# **Amendment Report**

**Licence Number** L9013/2016/1

**Premises** Dalgaranga Gold Project

**Date of Report** 19 November 2024 (FINAL)

Figure 5: Predicted drawdown for operation of Never-Never underground

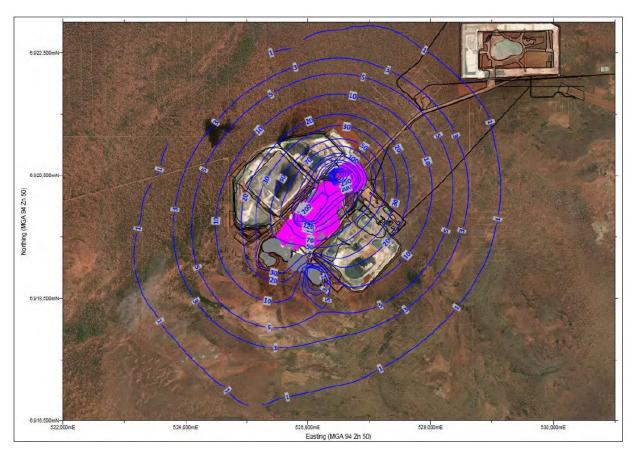
The use of pasted tailings below the groundwater table may result in heavy metals and/or salts being released as groundwater interacts with the pasted tailings. Initially, groundwater will not interact with the underground pasted tailings while mining is occurring due to a dewatering cone of influence. The dewatering effects are expected to extend up to 3km in a radial pattern from the Gilbeys pit (see Figure 5).

Following mine closure, the underground workings will gradually flood as the aquifer recovers which is expected to take approximately 12 to 16 years and it's at this stage groundwater is likely to start interacting with the paste tailings.

Figure 6: Modelled particle tracking results

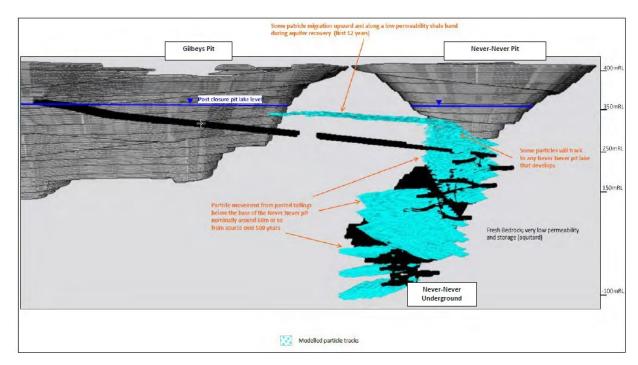
The Licence Holder modelled groundwater flow in a post closure simulation (500 years) using particle tracking (see Figure 6) and determined the following:

- Solute potentially released from the pasted backfill below the base of the Never-Never open pit (where pasted backfill will be used) is predicted to move laterally up to approximately 50m away from the underground workings (see Figure 6).

- As the aquifer recovers to a level within the more permeable fracture zone aquifer above the underground workings, the rate of groundwater movement is expected to increase and could transport some solute with it. Any solute brought within the fracture zone aquifer is expected to either report to the Never-Never open pit lake or migrate along a low permeability shale band towards the Gilbeys pit, collecting within a zone adjacent to the pit (see Figure 6).

- The Gilbeys and Never-Never pit lakes will eventually form permanent groundwater sinks inducing local groundwater flow towards them; therefore, any potential solute generated from the pasted tailings will be contained within the pit lake sink.

1. During mining operations, groundwater is not expected to interact with the pasted tailings due to dewatering occurring at the Premises. Post mine closure (dewatering ceased), the aquifer is expected to recover, and the underground workings will start to flood.

- 2. A flow connection between groundwater at the Never-Never underground and surface water bodies that will develop in the Gilbeys and Never-Never pits is expected to occur over an estimated 12–16 year period post mine closure.

- 3. Any solute generated by groundwater contacting the pasted tailings will be captured within the pits as they will act as groundwater sinks inducing local groundwater flow towards them.
